**Historical Architectural Review Board  
COA Final Review Sheet**

**HDC-2023-00076**

**Address: 1143 W. Linden Street**

**Proposal: Replace non-historic bow window with three double-hung sash windows.**

**Front façade of 1143 W. Linden Street, 2021.  
(Google StreetView)**

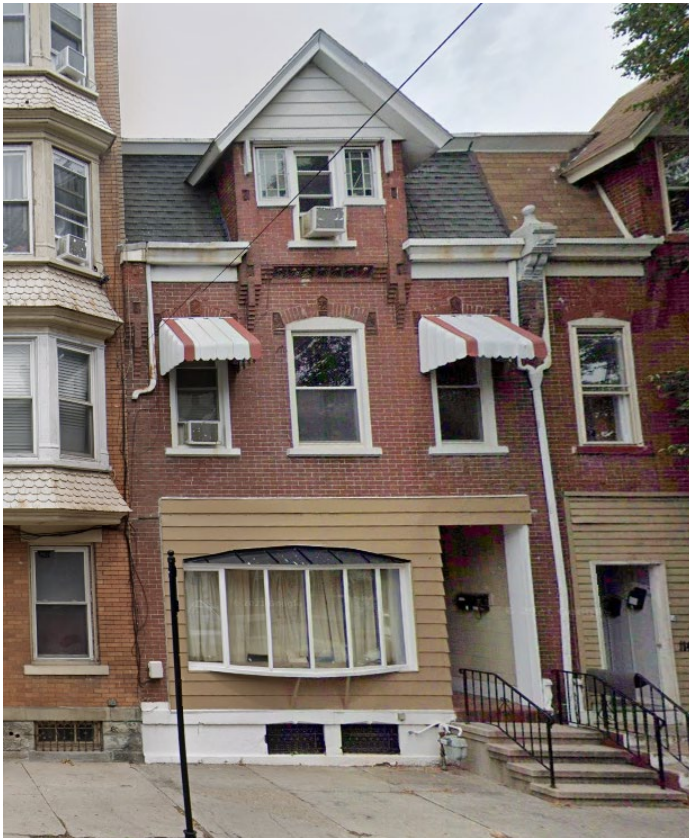
The existing bow window is an alteration of the original design, which likely consisted of two one-over-one double-hung sash windows at the first story with a single entryway. The 1932 Sanborn map indicates that the property was a dwelling and likely had not yet been altered from its original residential appearance. Staff presumes that the first-story brick was removed and a storefront was inserted into the ground story at some point in the mid-twentieth century, though no documentation has been found. Staff contends that the existing bow window has no architectural or historical significance and that the proposed configuration would be acceptable and would comply with the guidelines, specifically Guideline 3.5.10.

Approval, provided an appropriate wood, aluminum-clad wood, or composite window is installed, pursuant to Chapter 3, Section 3.5 Windows.

**Detail of bow window, 2021.  
(Google StreetView)**

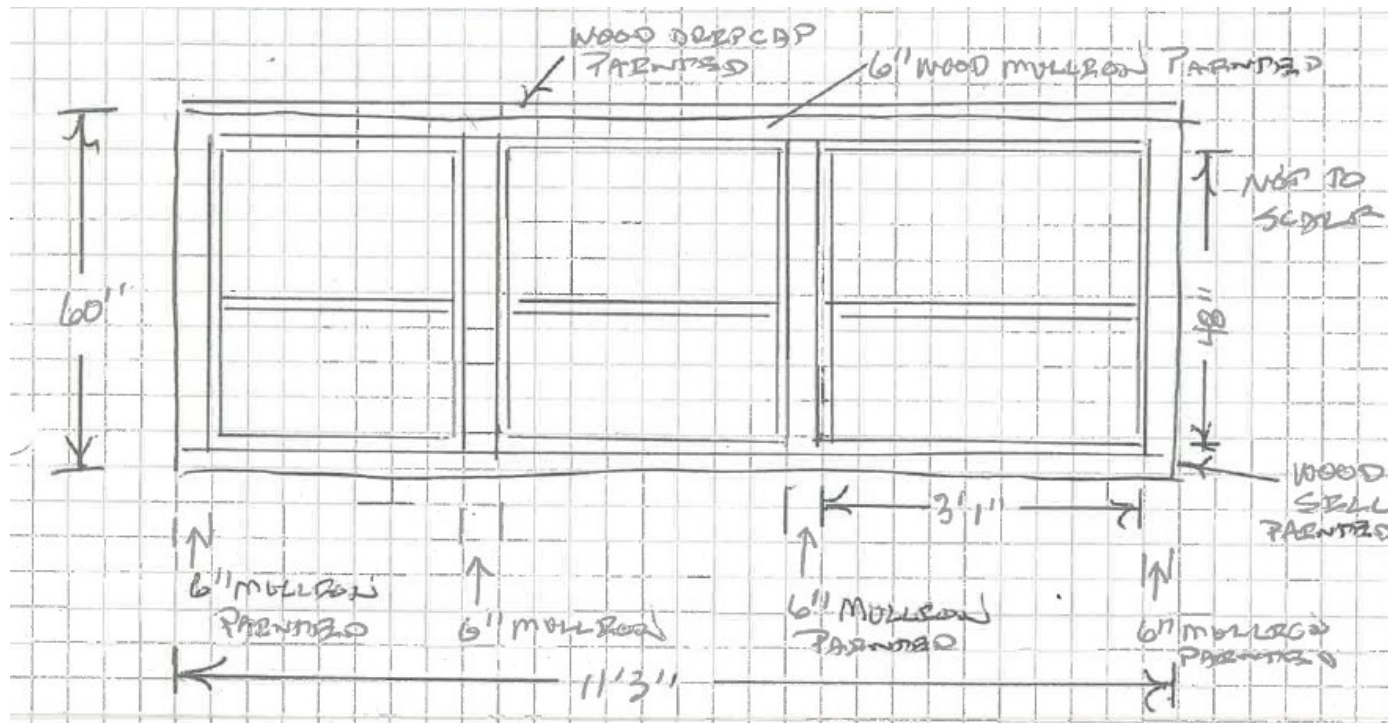
Regarding the material, staff notes that the proposed windows would be Kolbe Forgent series, which is a composite of fiberglass and a UV stable polymer. The combination of fiberglass and a polymer is not a composite material typically approved. Typical composites include wood and a polymer. Guideline 3.5.9 allows for composite wood or fiberglass windows with paintable exteriors, and staff asks that the HARB determine whether the Kolbe Forgent windows comply with the guideline as a fiberglass and polymer composite.

Mr. Huber moved to approve the application on 11/6/2023 to replace the existing bow window with three composite one-over-one double-hung windows, pursuant to Section 3, Chapter 3.5 Windows. Mr. Lichtenwalner seconded the motion, which carried with unanimous support.
